TRAFFIC AND TRANSPORTATION CLOSE OUT REPORT IN ACCORDANCE WITH SECTION 38 OF THE ROAD TRAFFIC ACT, 1994, AS AMENDED BY SECTION 46 OF THE PUBLIC TRANSPORTATION REGULATION ACT 2009

Re: PROPOSED BLOODMILL ROAD TRAFFIC STOP/GO SYSTEM

Date: 12.04.2024

Figure 2.2 Bloodmill Road Traffic Management Plan Part 1

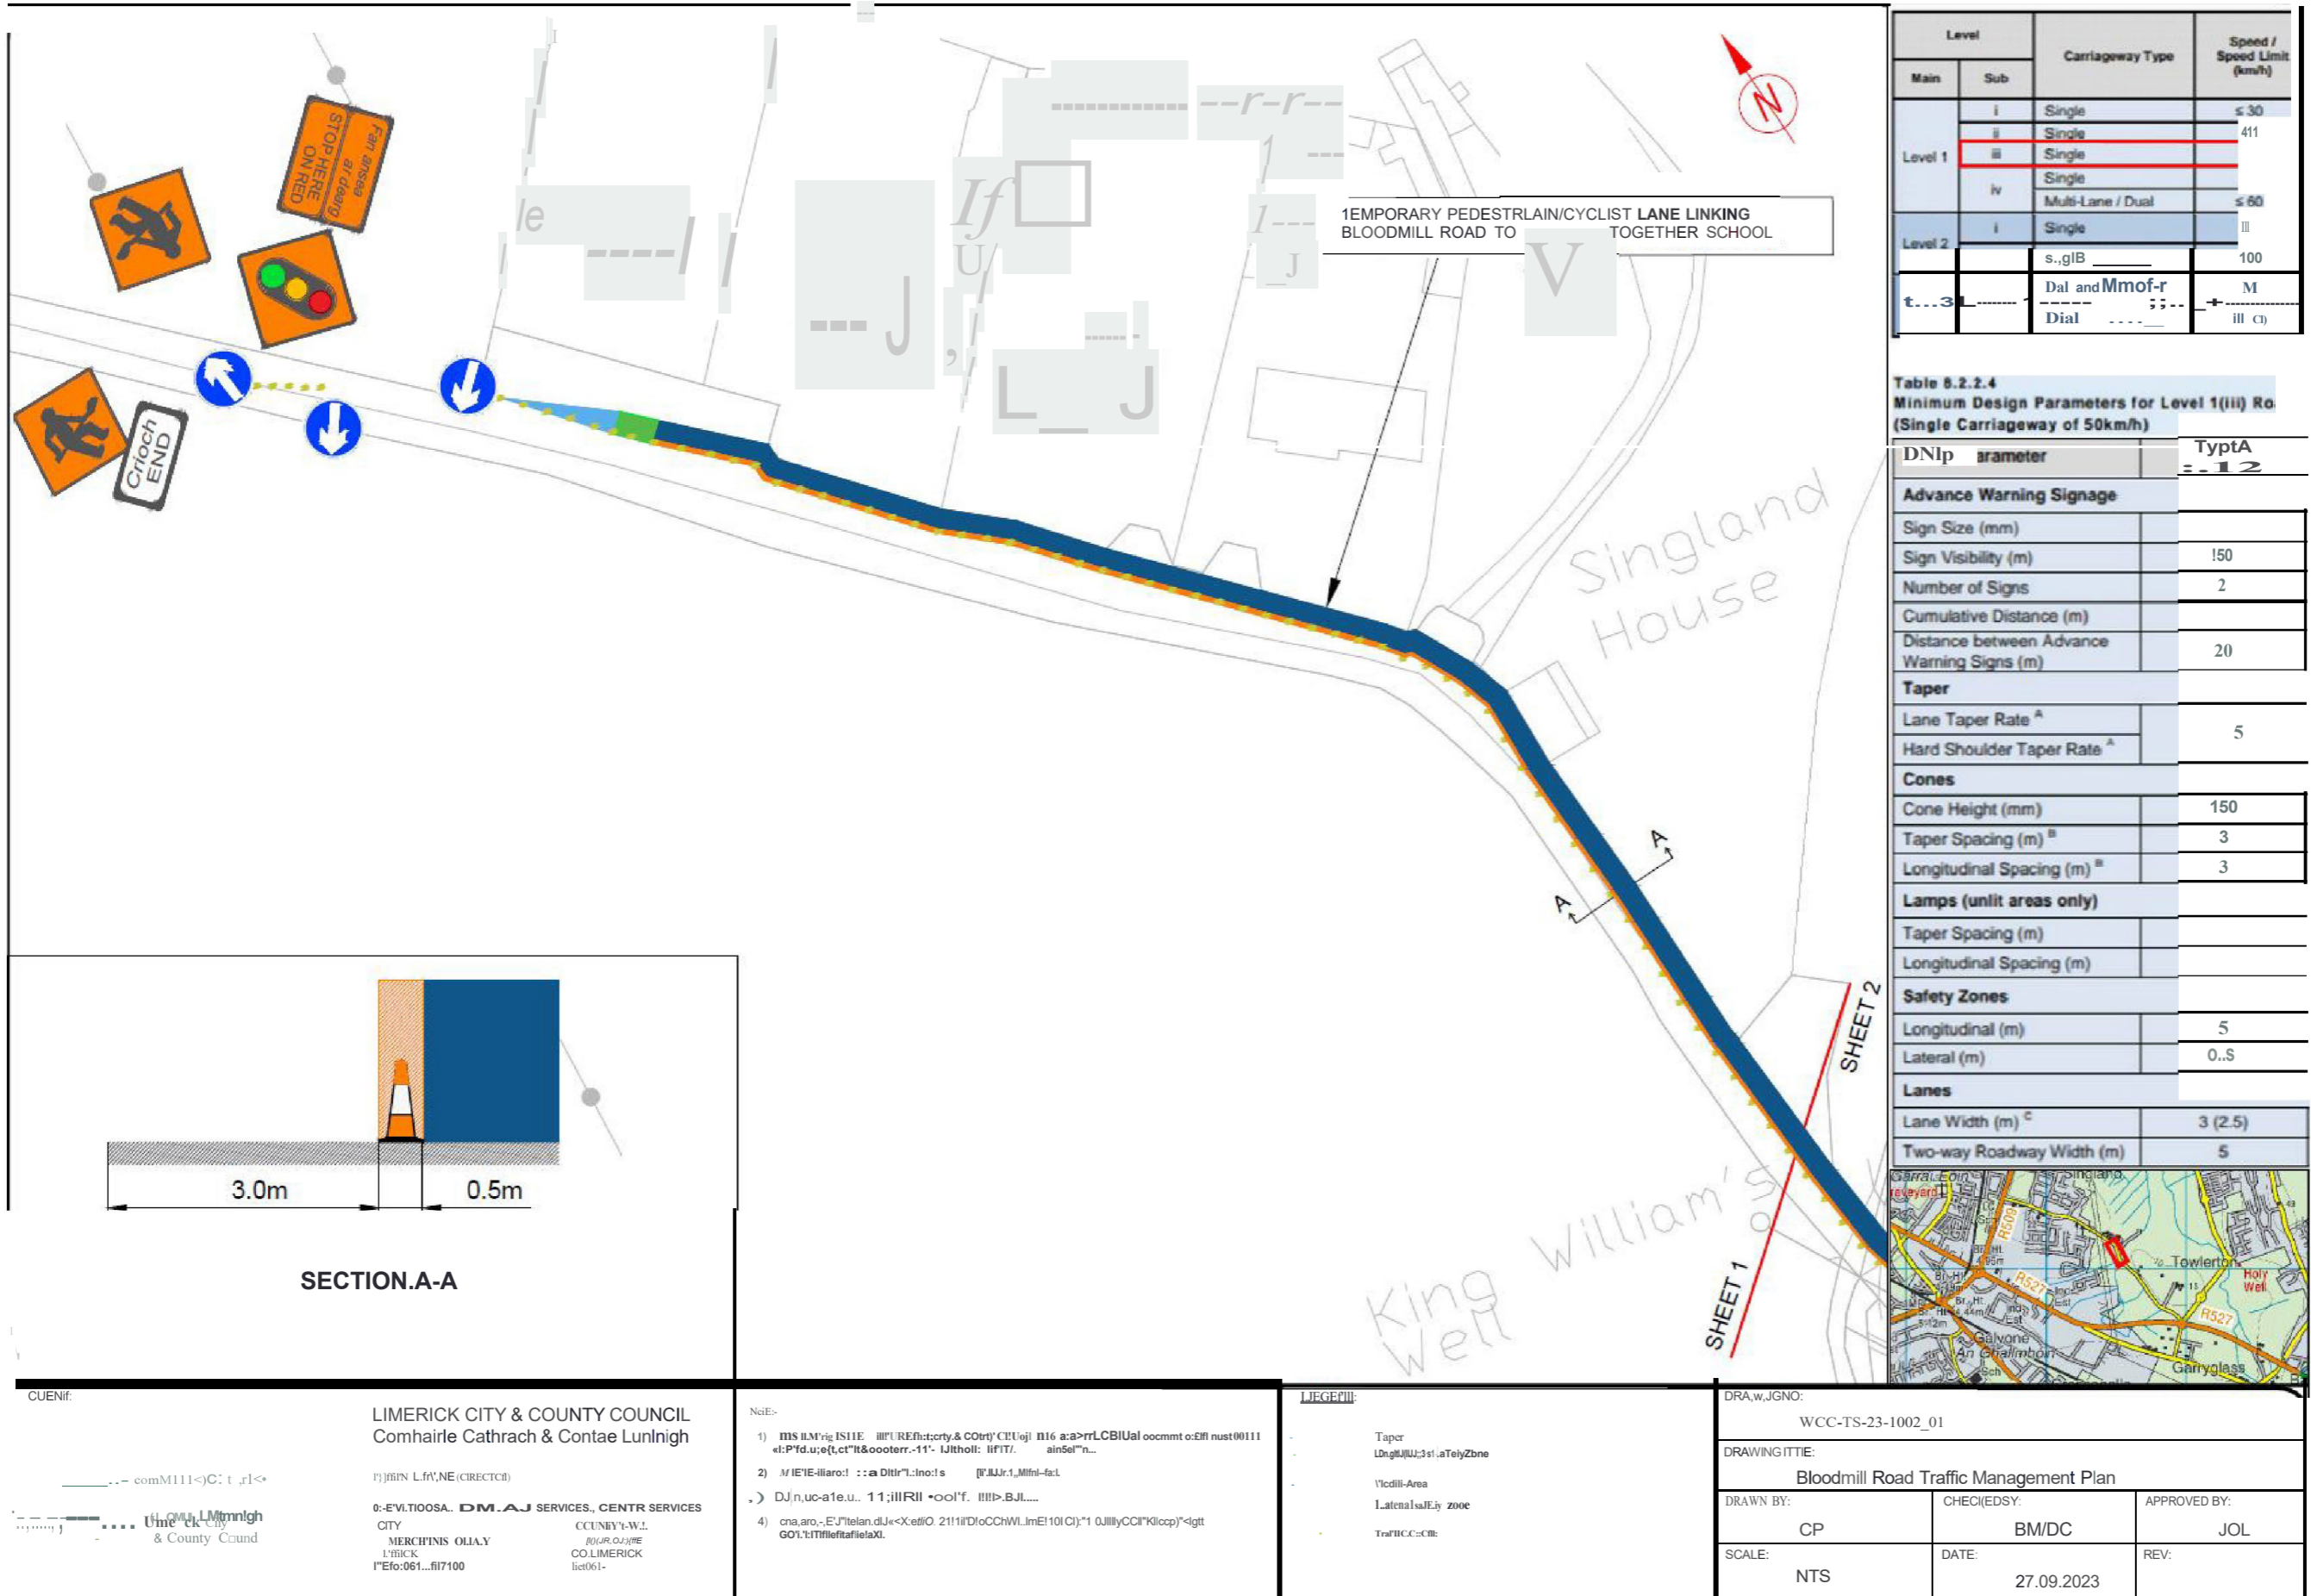
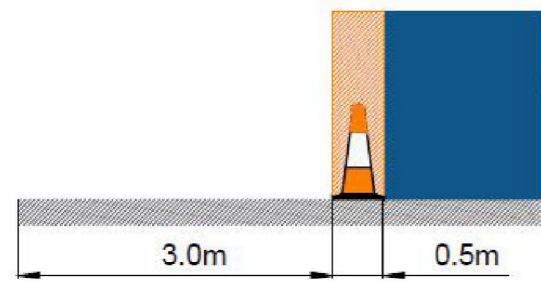
I live in the Glenbrook/Glendale housing estate. I object to such a system being put in place because I believe it will lead to a lot of traffic jams and delays in the mornings. I am a nurse and I work in the Annacotty area. There has already been an increase in traffic in the mornings especially since the new Educate Together Secondary School opened. There is often a queue to get through the roundabout beside Northern Trust.

I object to the proposed Bloodmill Road traffic light system as I believe it will lead to traffic congestion.

I believe that a stop/go traffic light will cause huge traffic congestion and queues on both ends. This will lead to long delays for motorists using this road.

The second exit from Glendale/Glendale Lawn housing estate has opened recently. This exit is nearly opposite to the new housing housing estate of Amharc Muileann (137 houses). The current proposal is to put the start of the the stop/go traffic lights just down the road from these housing estate exits. During busy times, this will cause long traffic tailbacks/queues at the traffic light which will then cause further problems for cars trying to enter/ exit the housing estates. It will become a bottleneck.

2) There is no traffic data provided to support the decision of of the location or the duration of the works.

There is no information on what effect a stop/Go system will have on the traffic. This is going to cause extreme delays on this road, especially at peak times. Tail backs reaching to the Garryglass Roundabout in one direction or back to Cloughaun GAA pitch in the other direction are not unrealistic and this will cause road safety issues as well as access problems for local residents trying to access/leave the housing estates along this road.

How will access to and from the housing areas be ensured when traffic tails back past the entrances?

The proposed scheme has been revised. An off road solution was designed and agreed with all immediate stakeholders. This solution has been implemented and will have no impact on traffic flow on the Bloodmill Road.

The proposed scheme has been revised. An off road solution was designed and agreed with all immediate stakeholders. This solution has been implemented and will have no impact on traffic flow on the Bloodmill Road.

The proposed scheme has been revised. An off road solution was designed and agreed with all immediate stakeholders. This solution has been implemented and will have no impact on traffic flow on the Bloodmill Road.

Figure 2.3 Bloodmill Road Traffic Management Plan Part 2

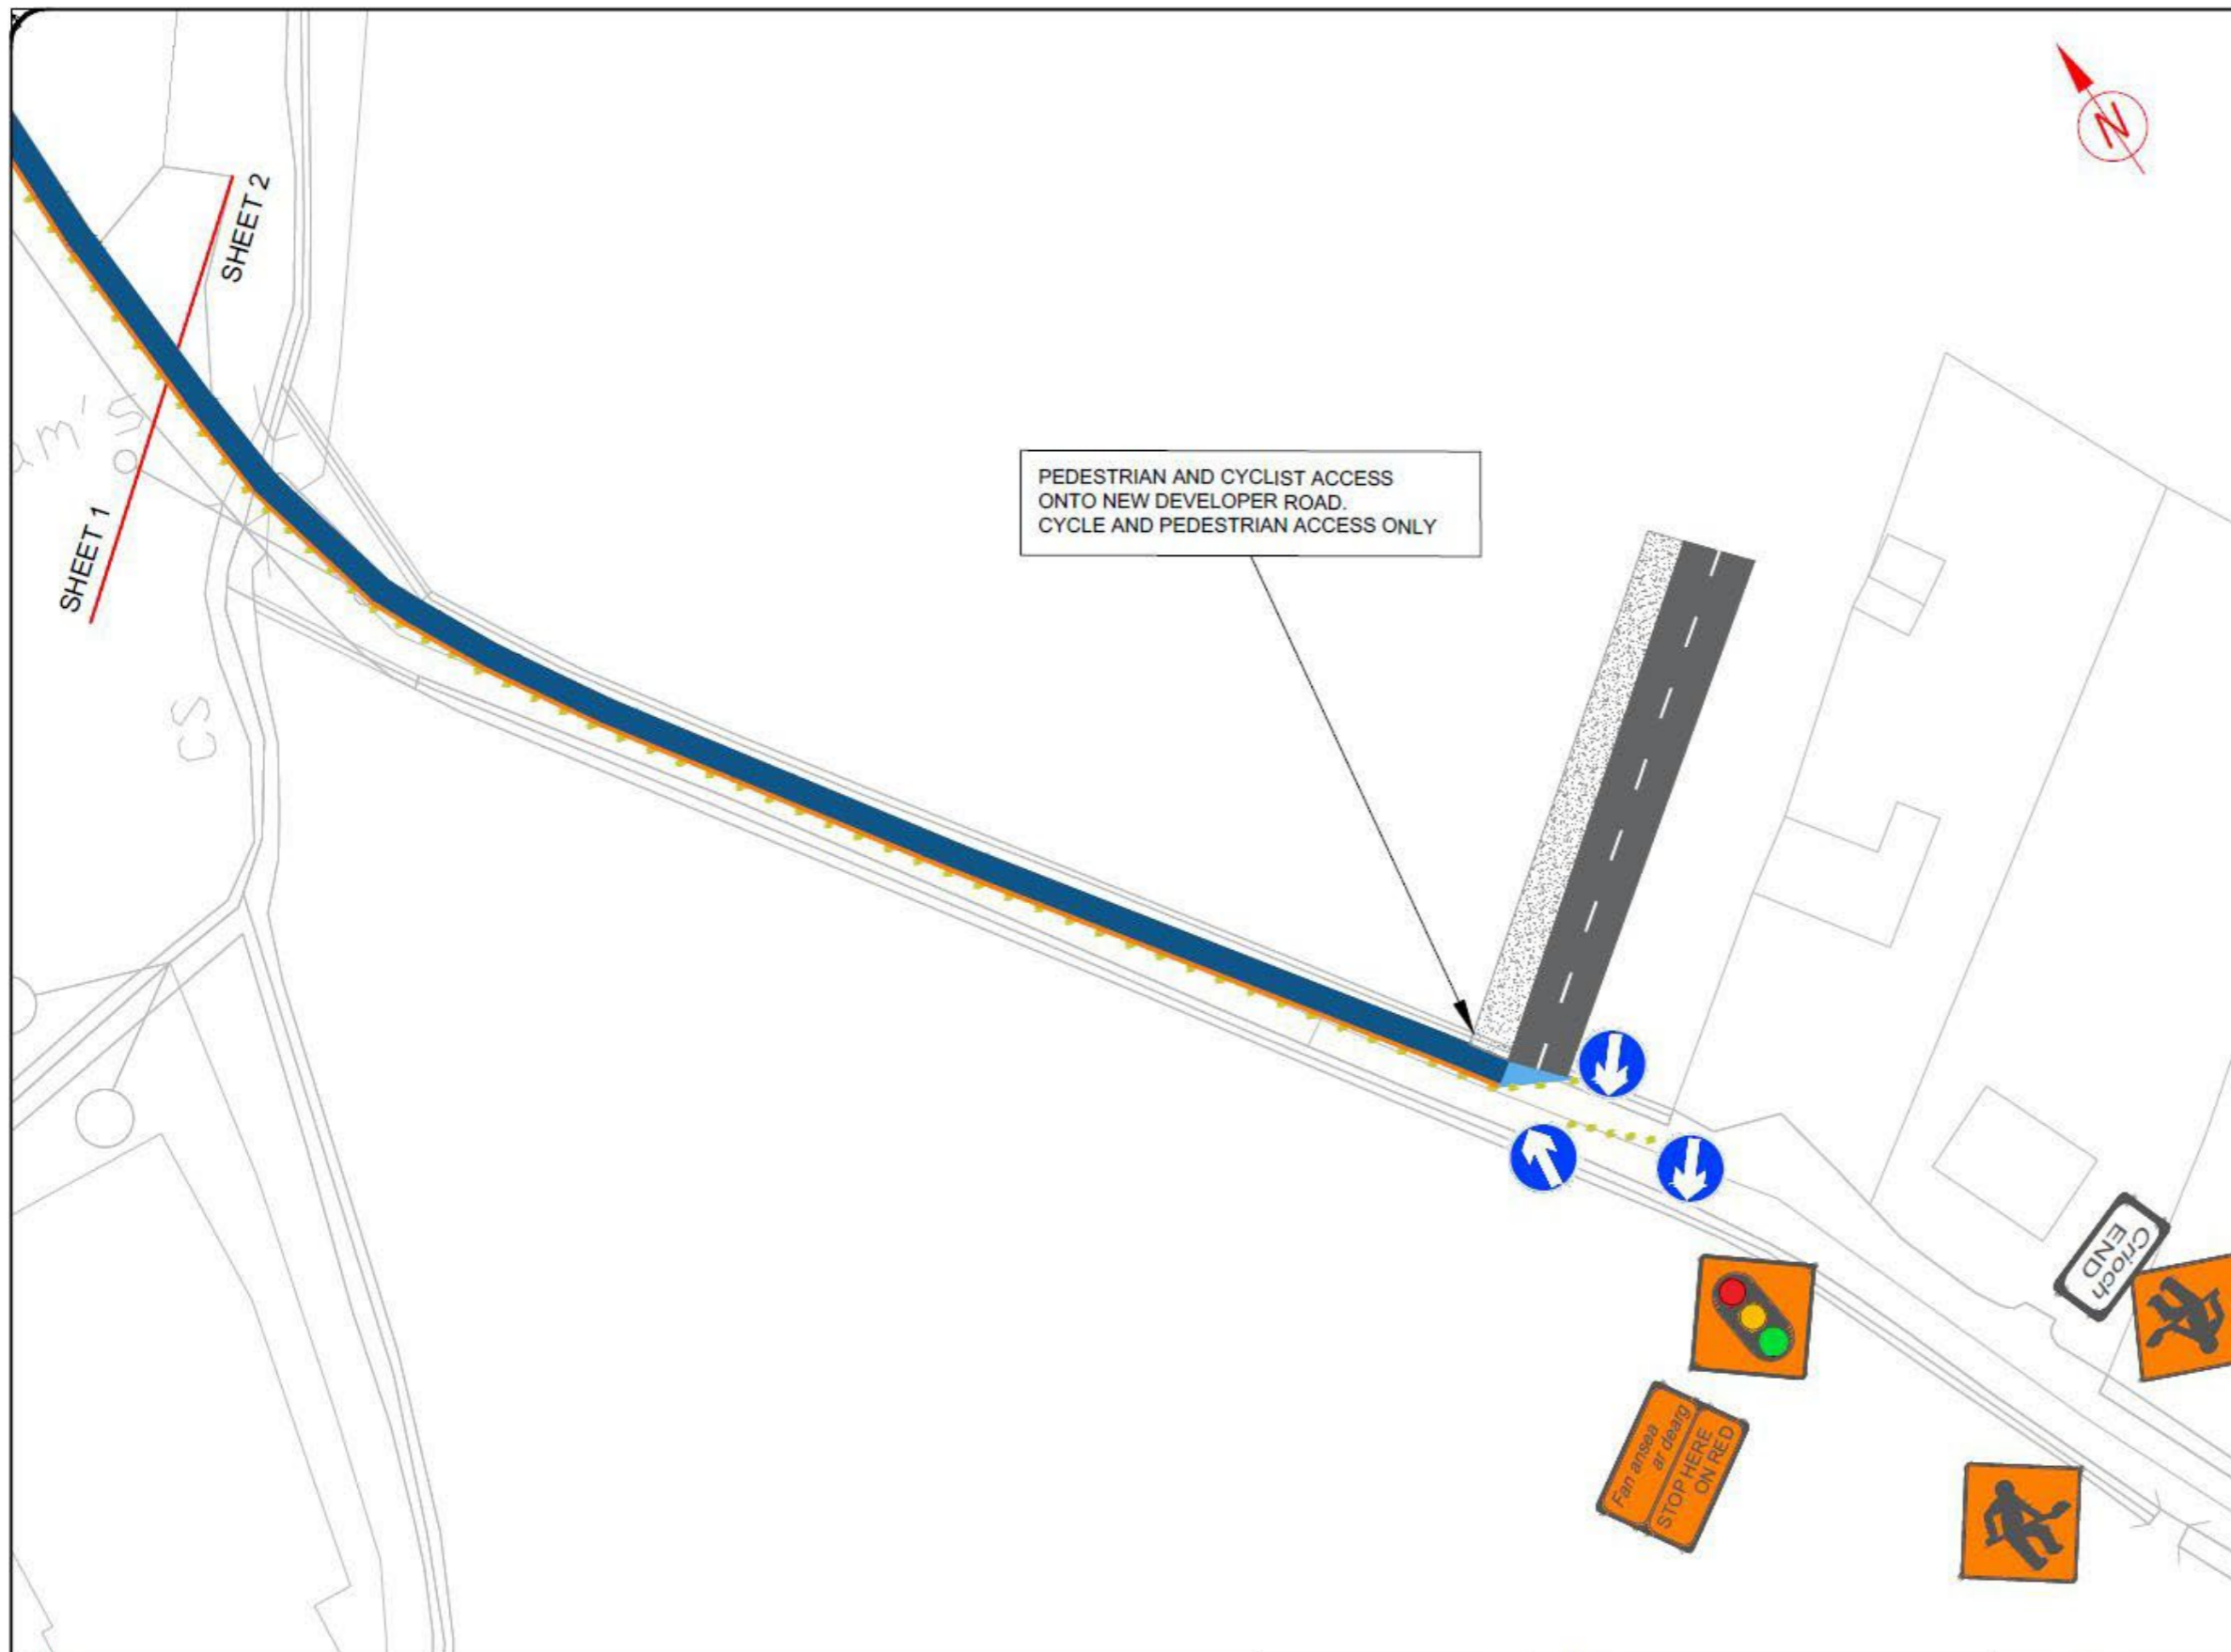
Hello, I would firstly like to say I have no objection against the Stop /Go planned for Bloodmill Rd as safety of Children must come first. My objection is where the Council plans to position the traffic lights as I believe it will make entering and exiting my property potentially dangerous for vehicles as I expect a large stacking of traffic opposite my House most of the time therefore increasing the likelihood of accidents or traffic congestion..I have met with a Council Engineer and expressed my concerns and feel moving the lights a little closer to the ballysimon rd would be a lot safer for everyone involved.

The proposed scheme has been revised. An off road solution was designed and agreed with all immediate stakeholders. This solution has been implemented and will have no impact on traffic flow on the Bloodmill Road.
